STAFF REPORT
COMMUNITY DEVELOPMENT DEPARTMENT

HEARING DATE: 8/22/2023
TO: Mayor & City Council
FROM: Sonya Allen, Associate Planner
208-884-5533
SUBJECT: Kingstown Subdivision No. 1 - FP
[FP-2023-0007](#)
LOCATION: 2610 E. Jasmine Ln., in the south 1/2 of
Section 32, T.4N., R.1E.

Final plat consisting of 17 buildable lots and 4 common lots on 4.17 acres of land in the R-8 zoning district for Kingstown Subdivision No. 1.

KINGSTOWN SUBDIVISION - PHASE I LANDSCAPE PLANTING PLAN

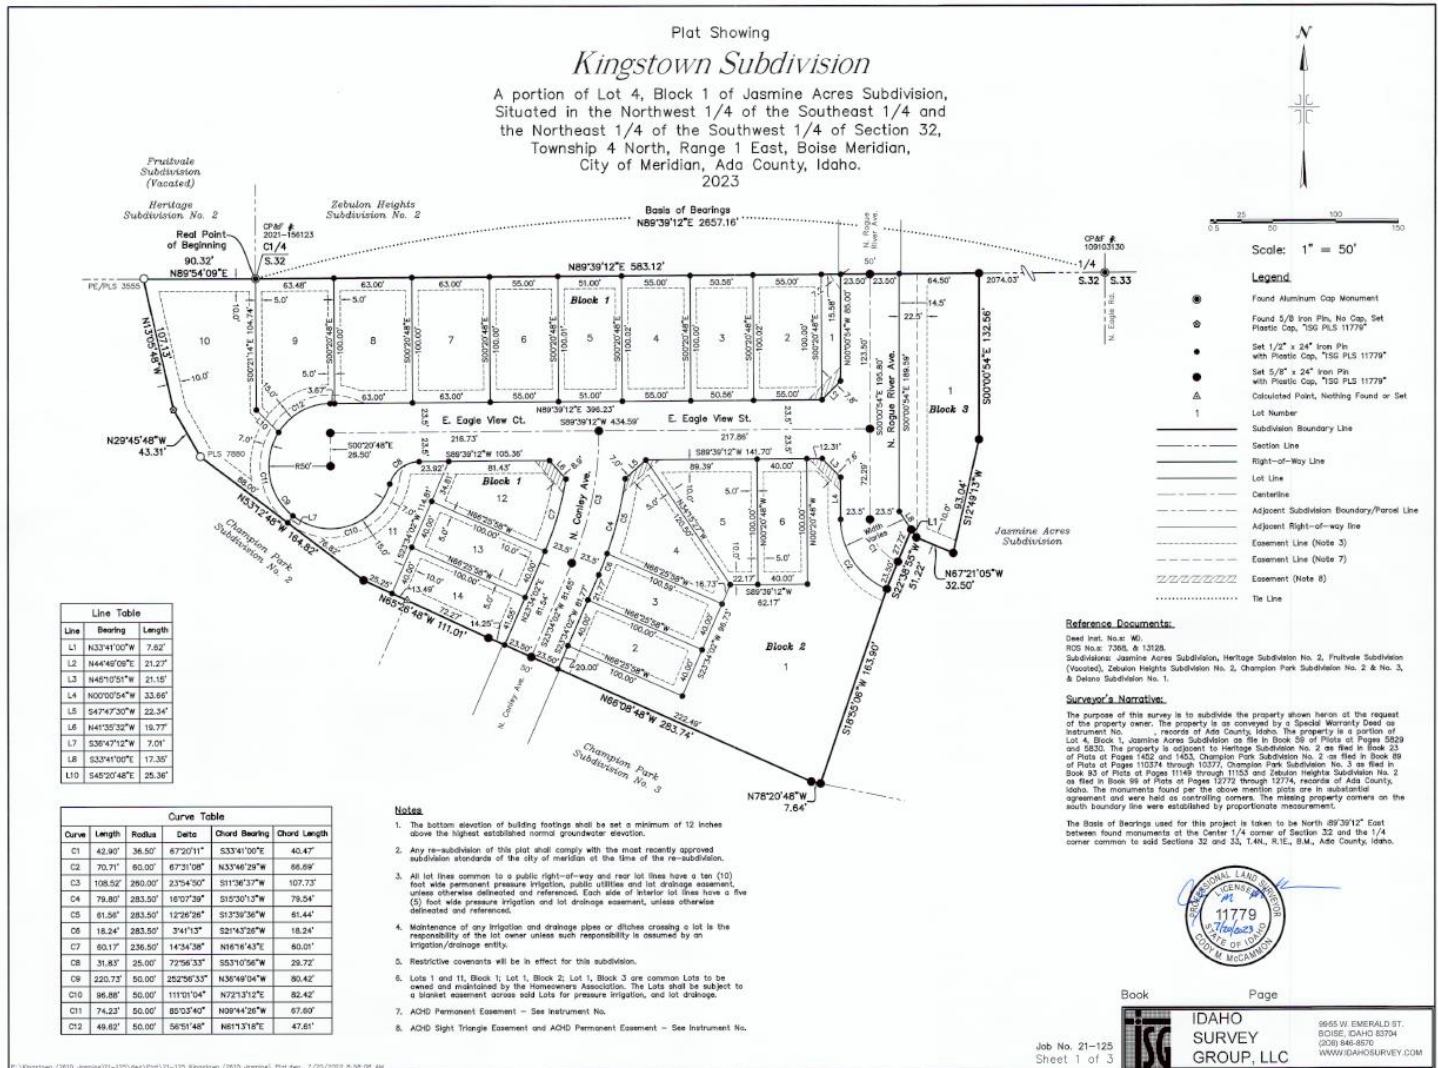
5. Prior to City Engineer signature on this final plat, revise the landscape plan shown in Section V.C, prepared by Kimley Horn, dated 12/23/22, as follows:

- a. Depict a *detached* sidewalk with an 8-foot wide parkway and landscaping per the standards listed in UDC 11-3B-7C on Lot 1, Block 1 in order for the lot to count toward the minimum qualified open space requirement.
